TRANS/SC.3/WP.3/2002/14
5 March 2002

UPDATING THE EUROPEAN CODE FOR INLAND WATERWAYS (CEVNI)

Transmitted by the Central Commission for the Navigation of the Rhine (CCNR)

“Article 3.32 - Prohibition of smoking or using an unprotected light or flame

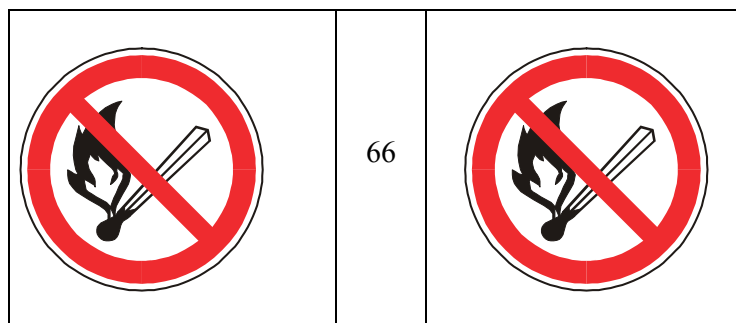
1. In the spring of 2000, the Central Commission for the Navigation of the Rhine amended article 3.32 of the Rhine Vessel Inspection Regulations (RVBR). The new provisions mean that sign No. 61 in Annex 3 prohibits not only smoking on board but also any unprotected light or flame.

4. It is therefore proposed that this issue should be considered during the next session of the WP.3 Working Party scheduled for June 2002 and that article 3.32 and annex 3, sketch 66 should be adapted accordingly. A proposal along these lines is set out below. Once this amendment has been included in CEVNI, CCNR will incorporate the sign in question in the Police Regulations.

5. Article 3.32 should be amended as follows:

1. If regulations prohibit

(a) smoking,

(b) using an unprotected light or flame,

on board, the prohibition shall be indicated by

Circular white boards bordered with red, with a red diagonal and a picture of **a lighted match, in profile.**

Boards shall be placed, as circumstances require, on board or on the gangway.

By derogation from article 3.03, paragraph 3, they shall be about 60 cm in diameter.

2. The boards shall be illuminated as necessary so as to be clearly visible by night.”
